Some Initial Comments on Elements of the WHA Analyses

AER RIANTA

DUBLIN AIRPORT MASTERPLAN

RESPONSE TO COMMISSION FOR AVIATION REGULATION QUERIES

Figure 1 - Conversion Ratios 1990 - 2002

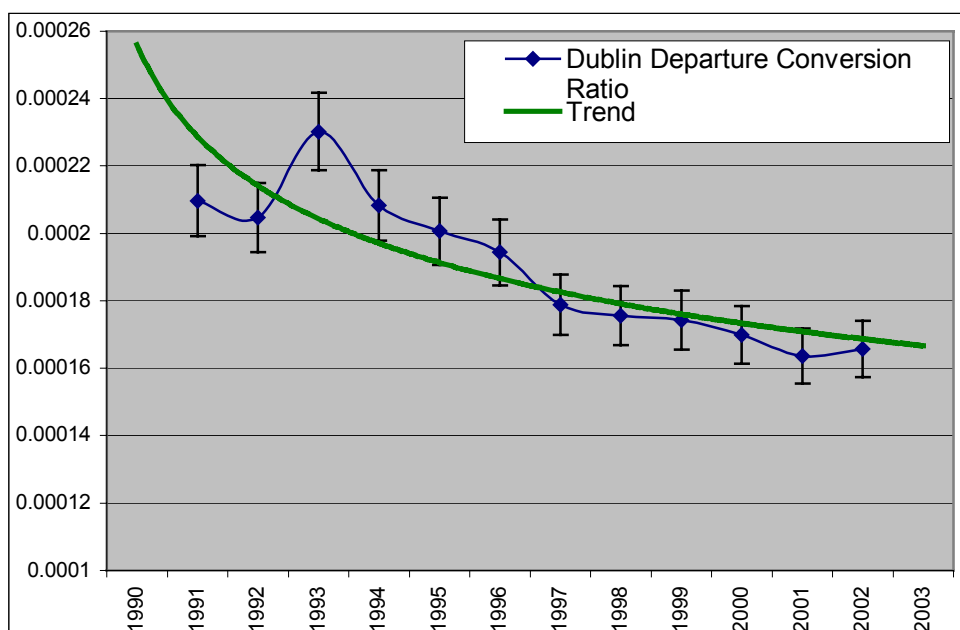
The conversion ratios proposed by the Commission reflect the actual conversion ratios for years 2001 and 2000 respectively.

The following table and Figure 1 show the actual conversion ratios for years 1991 to 2002 for Departures. In 1991, the value was 0.00021. In 2002, the value was 0.000166. The graph shows a decreasing trend with a +/-5% deviation.

It is worth noting that there are anomalies in the early and final years of this trend, the latter most likely a reflection of the unusual traffic profile associated with 2001 in the aftermath of the September 11th terrorist attacks. Anomalies of this nature, step changes and other effects underpin the risks associated with using conversion ratios per se in historic analyses and future long term planning of facilities.

Figure 4 - CADCL Resurvey of unusable areas October 2003

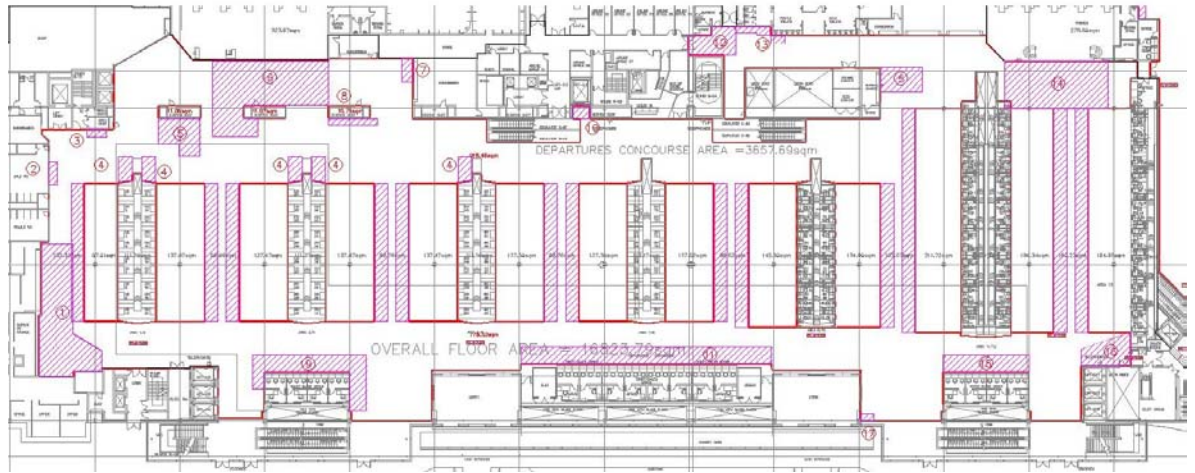
These areas were re-measured in October 2003 subsequent to the Commission's query in relation to "detuning".

The detuned areas referred to are shown in the following drawings followed by selected photographs to illustrate some of the dead or unusable spaces identified in detail in the drawings. All photographs are catalogued in Appendix A. Photographs not included in this report are available on request. (All photographs were not included to minimise file size).

Despite an exhaustive re-examination of the unusable areas, it can be seen from Table 4 that the Effective Circulation Areas Post Detuning in October 2003 are less than or have remained unchanged from the time of the Baseline Report thereby validating the approach adopted in the Baseline Report.

Figure 8 - Equivalent Overspill Areas from Check-In Queues

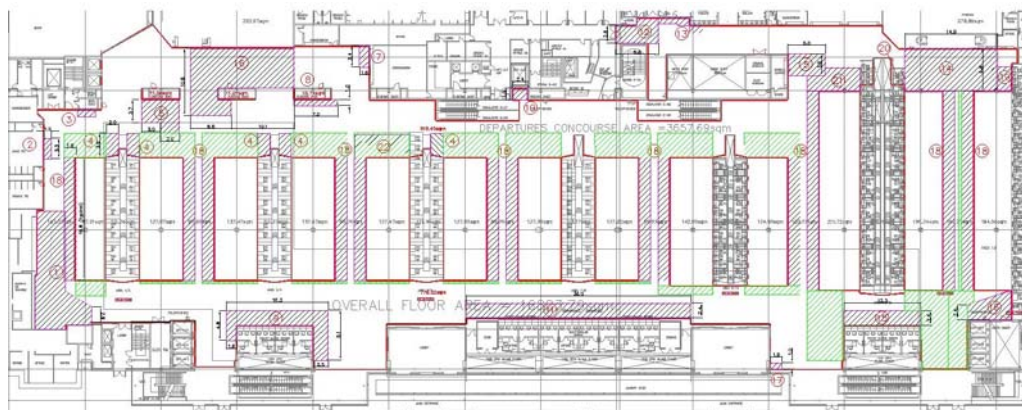
Detuning Exercise assumes no spill over between circulating space and queuing space.

The calculation shows that even with 67% of desks occupied, the profile of arriving passengers during the Busy Hour in 2002 causes very significant overspill into the CADCL. Under Baseline conditions, the detuned area available for circulating passengers during the busy hour would be eroded by 583sqm from 2495sqm to 1,912 sq m, which is equivalent to a 23% erosion of circulation space. This would translate into a proportionate reduction in the Busy Hour population that the reduced space could support at an acceptable Level of Service.

The following drawing shows the dramatic effect this overspill would have on the already detuned spaces. It highlights an equivalent area to the overspill effect in green.

Green Cross Hatched Area	Denotes the equivalent areas within the CADCL that would be required to handle the overspill from the congested check-in queues.
Pink Cross Hatched Area	Denotes unusable areas that have been extracted to arrive at the effective circulation area post detuning.

Figure 9 - Timeline Reflecting August 2003 Conditions

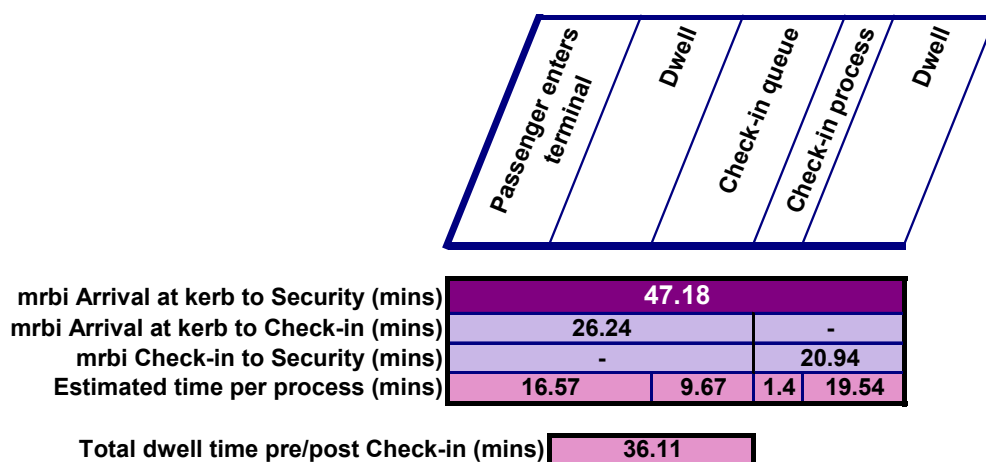
A dwell time of 30 minutes for passengers and 20 minutes for escorts was used in the application of the BAA formula for calculating the capacity of the CADCL. This was based on survey data from 2002.

The dwell time data can now be updated to reflect the outcome of TNS mrbi’s survey of August 2003 (Appendix C). The dwell time is now 36.11 minutes as detailed in Figure 9.
